## TRANSMITTAL COVER SHEET

**DATE:** July 23, 2019  
**TO:** ALL PLAN HOLDERS  
**FROM:** PATSY STINSON  
**PROJECT:** EVERGREEN LAGOON UPGRADE (REBID)  
SRF PROJECT NO.: CS010335-05  
GMC PROJECT NO.: CMGM190092  
**RE:** ADDENDUM #1

# ADDENDUM NUMBER 1

## EVERGREEN LAGOON UPGRADE REBID

**D-301**

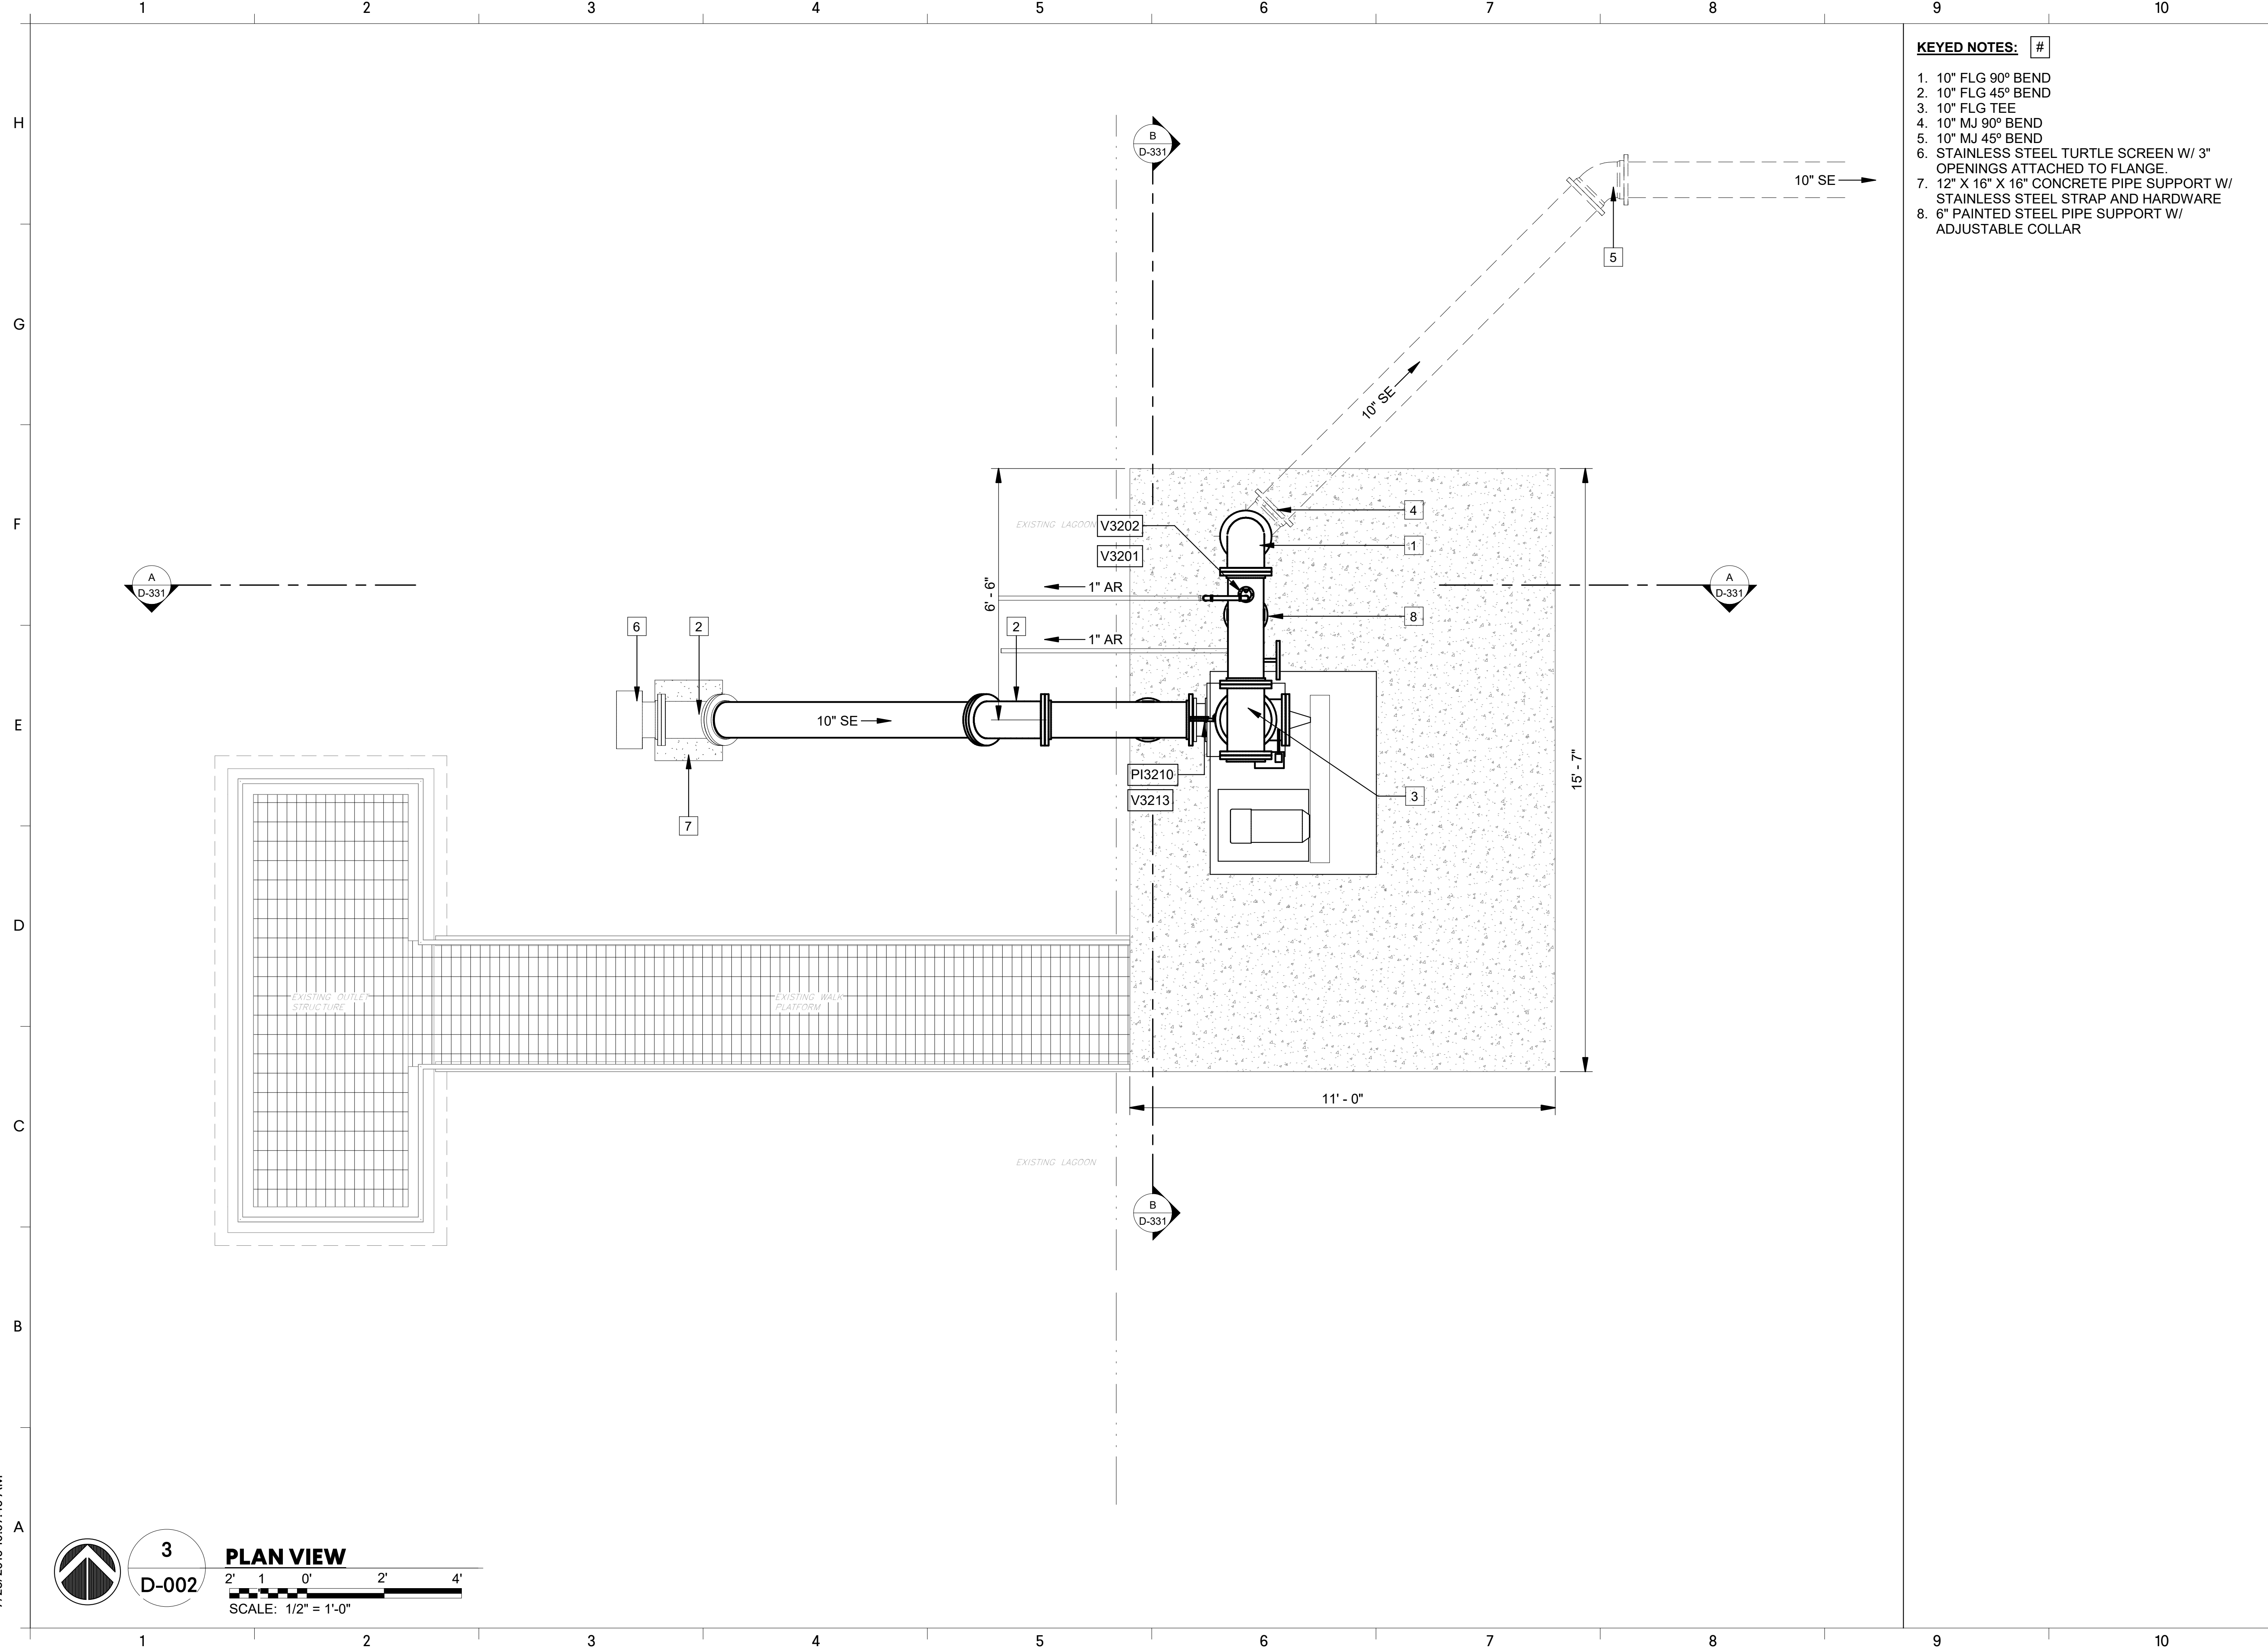
- 1.3 Sheet D-301 and Sheet D-331 have been revised and are included as an attachment to this addendum.
- 1.4 A revised Proposal Form and Bid Bond are attached for the purpose of bidding this Project. A new bid item for Debris Disposal has been added as Item Number 22. A Substitutive Alternate Bid is included in the Proposal to increase the pond liner thickness from 30 mils to 45 mils.

**D-331**

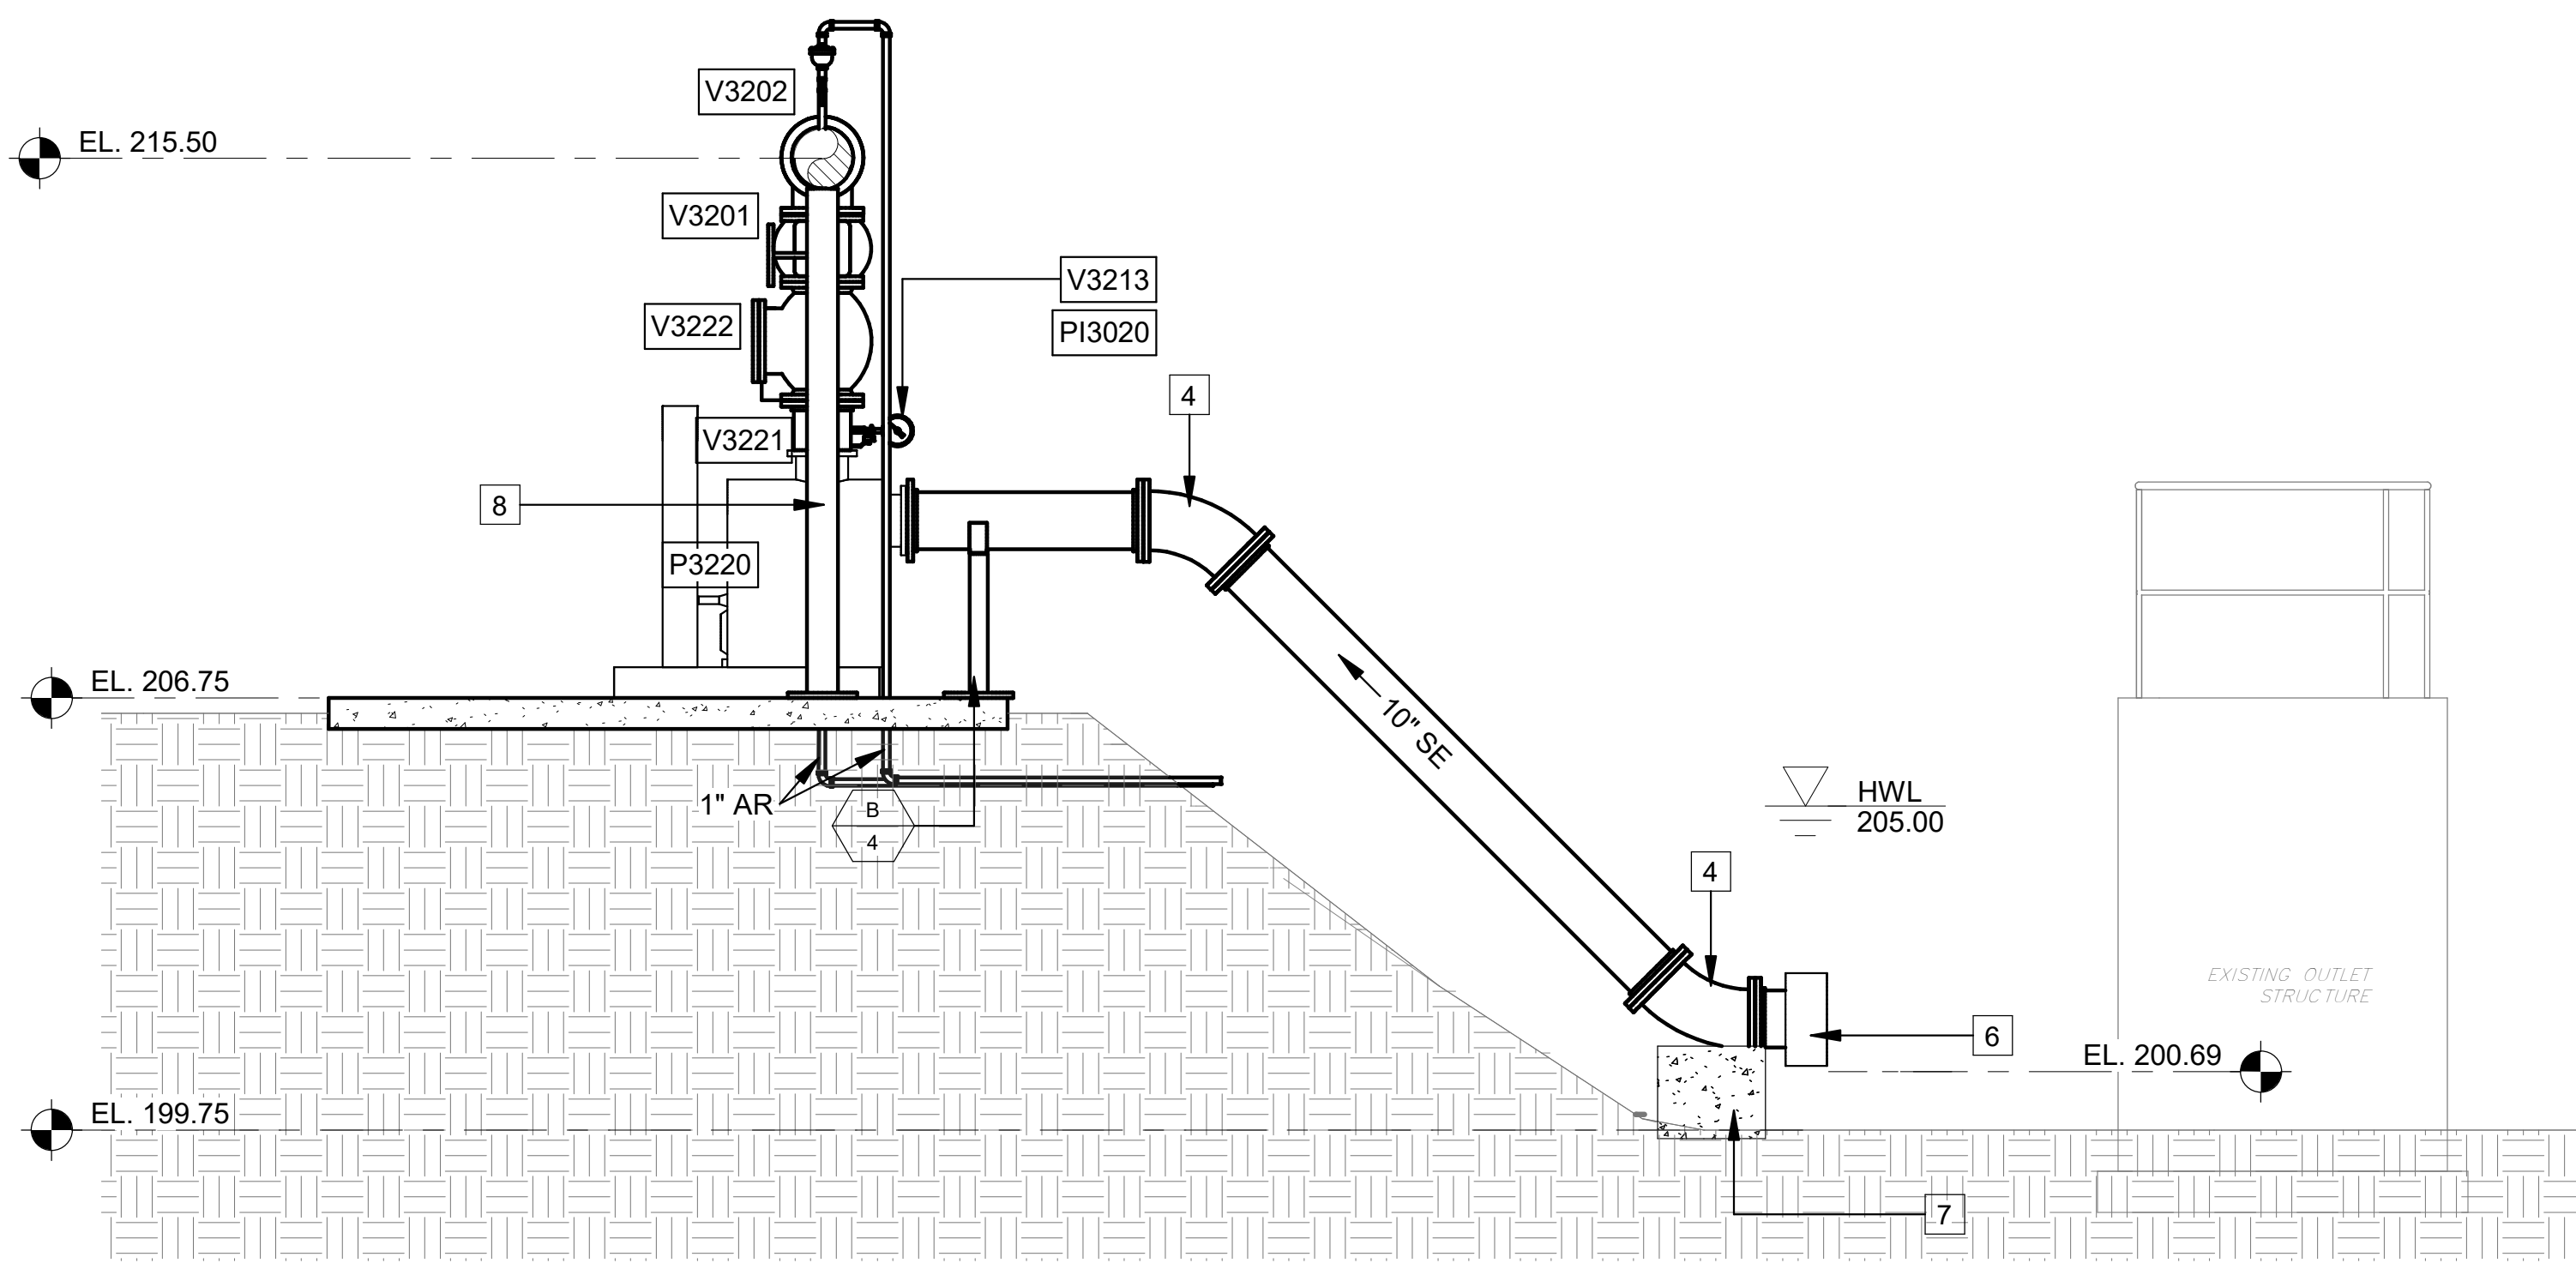
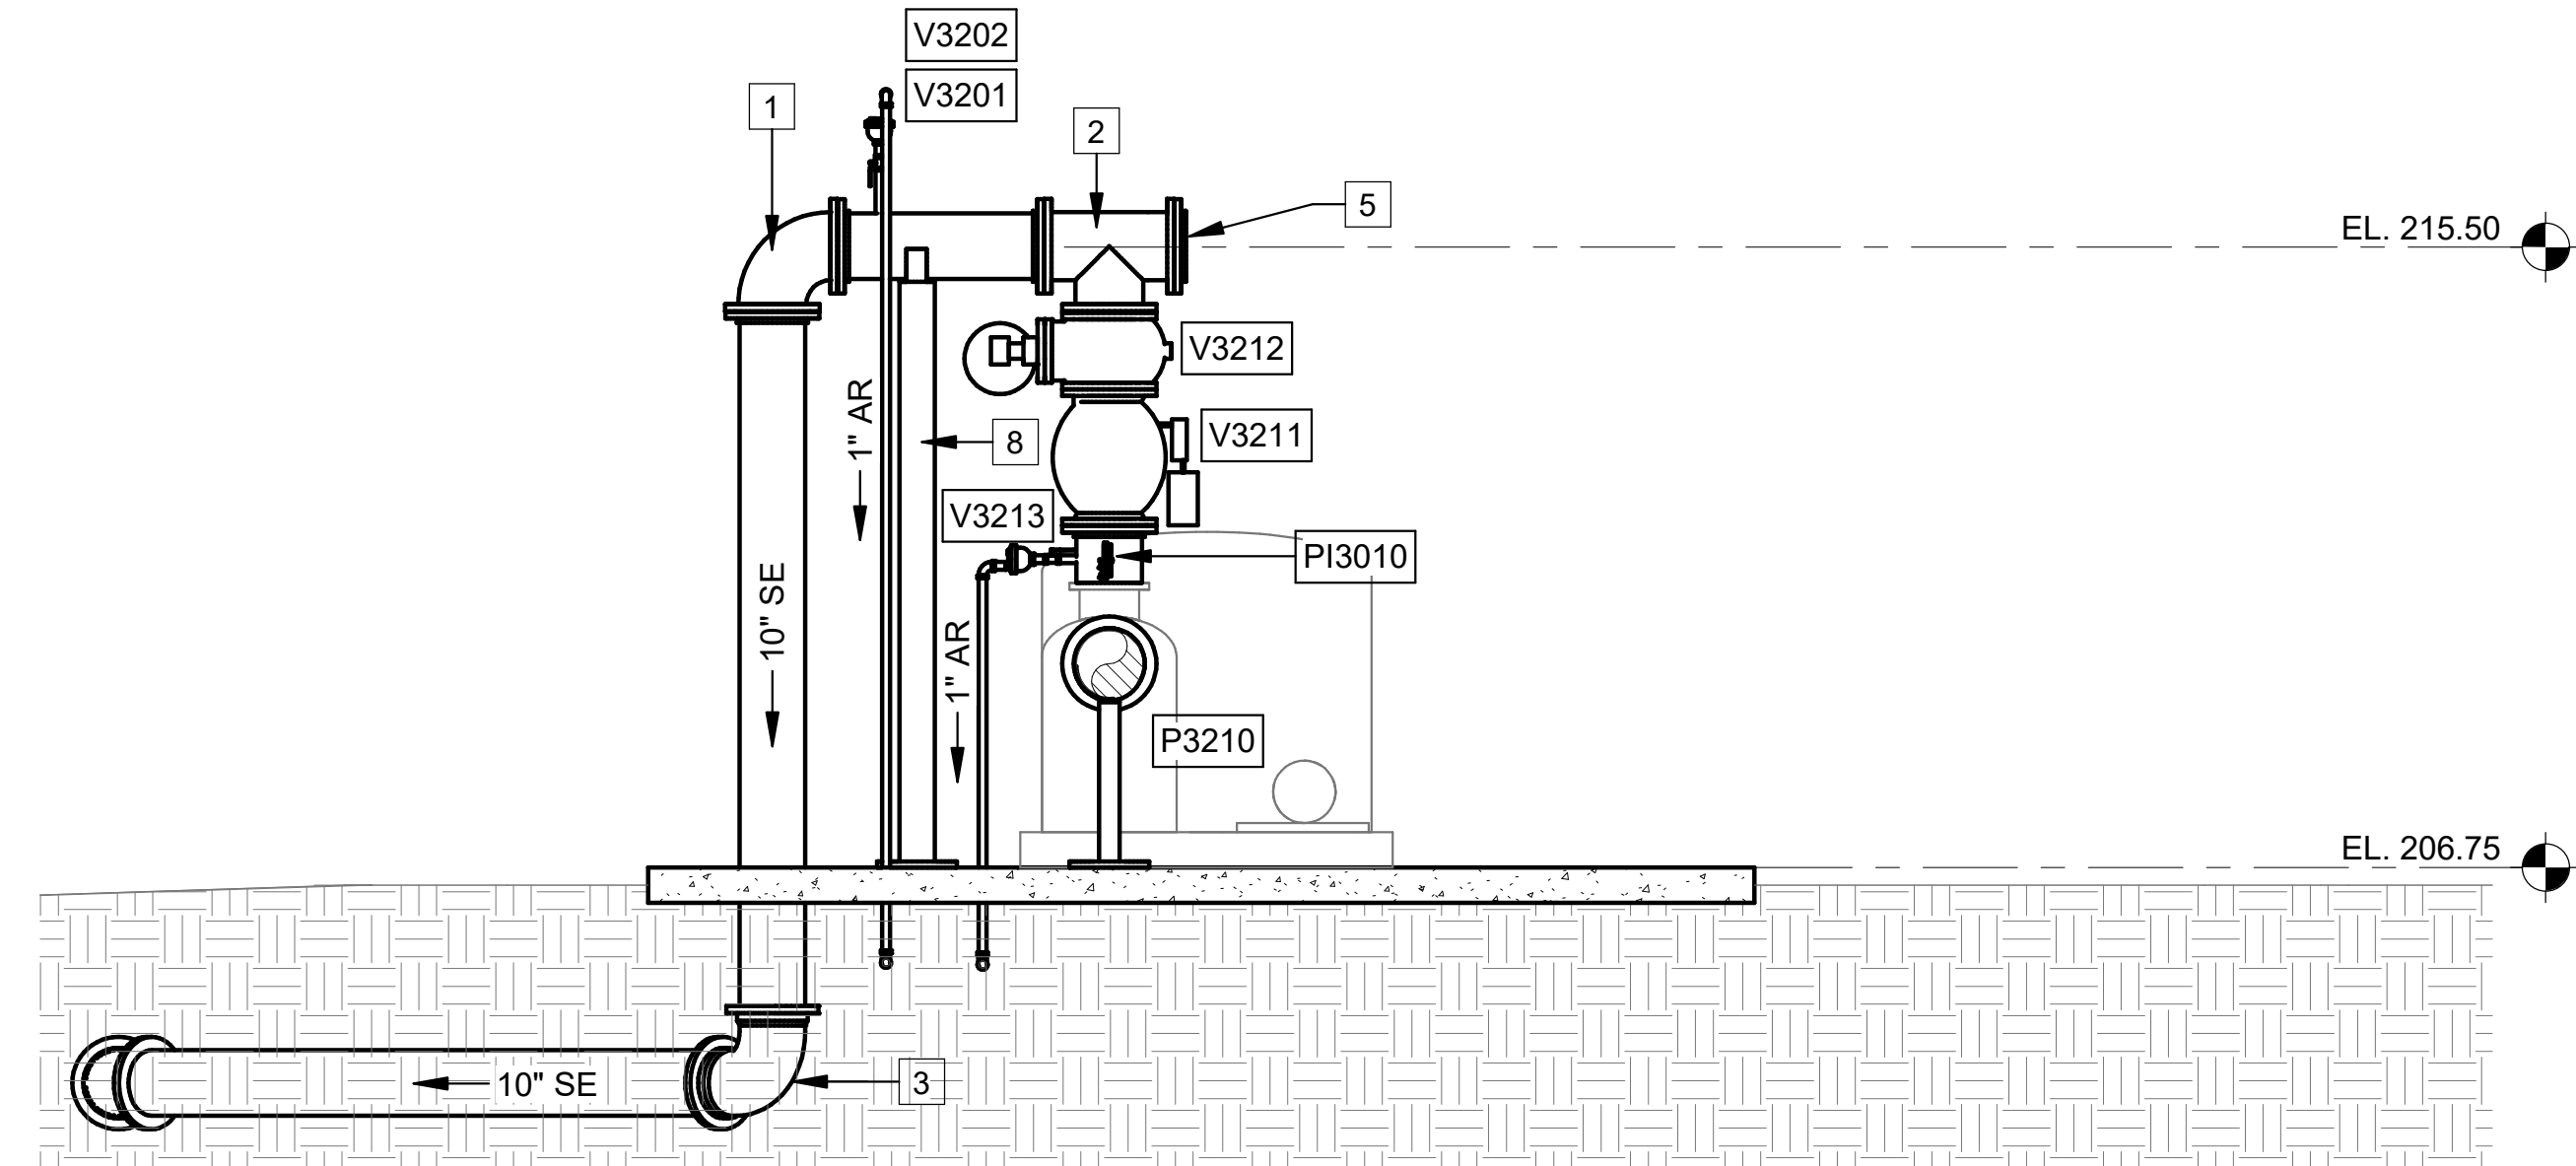
- 2.11 **Question: Do we include each individual concrete slab with each respective Process bid item?**  
Answer: Yes
- 2.12 **Question: On sheet D-331, valves “V-3221” and V-3222” appear to be from the previous bid, in which there were two pumps installed here instead of one. These are tagging valves “V-3211” and V-3212” again. Also, valves “V-3211” and “V-3212” are listed in the valve schedule on sheet D-904 to be 6” diameter, shouldn’t these be 10” diameter?**

Answer: The air release valve should be labeled as V4012 and the ball valve V4013 as indicated on Sheet I-114. These valves are in the valve schedule.
- 2.16 **Question: On sheet D-331, Detail A, “PI-3020” seems to be a tag from the previous bid. Shouldn’t this be “PI-3010?” Please clarify.**

Answer: Yes, valves V3221 and V3222 should be V3211 and V3212 on D-331. They are 10” valves.
- 2.13 **Question: The type of pipe material for the 1” Air Release lines at the DAF Pump Station is not given, please clarify.**

Answer: Yes it should be PI3010.
- 2.17 **Question: Section 01-10-00 - 1.14.A.2.e: Please clarify where the new influent gravity sewer lines, that are referred to in this item, are located on this project.**
